**03 Crank assembly**

Ticking noises at idle speed on vehicles with low mileage (< 10 000 km). Especially loud with cold engine . . . . .	B 17
Ticking noises from about 1500 rpm when engine cold and warm, also heard while driving . . . . .	D 17
Ticking noises from about 1500 rpm when engine cold and warm, also heard while driving . . . . .	G 17
Replacing front crankshaft radial seal . . . . .	H 17

### **03 Pistons**

### Replacing front crankshaft radial sealing ring.

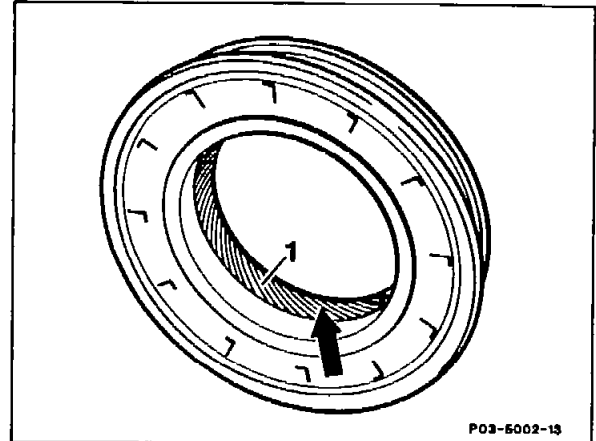
If oil leakages occur at the front of the crankshaft, it is only necessary in the most frequent cases to replace the crankshaft radial sealing ring. Replacing hub at the same time is only necessary in those cases where two wear tracks (grooves) are visible on the hub. For hubs which have only one wear track (groove) a radial seal with a sealing lip offset 2 mm to the rear is available (repair version). If the sealing surface of the hub is only ground bright, only the standard version of radial seal may be fitted.

Press the radial seal dry (without grease) into the timing case cover and coat the sealing lip (Fig., item 1) with engine oil – do not use grease.
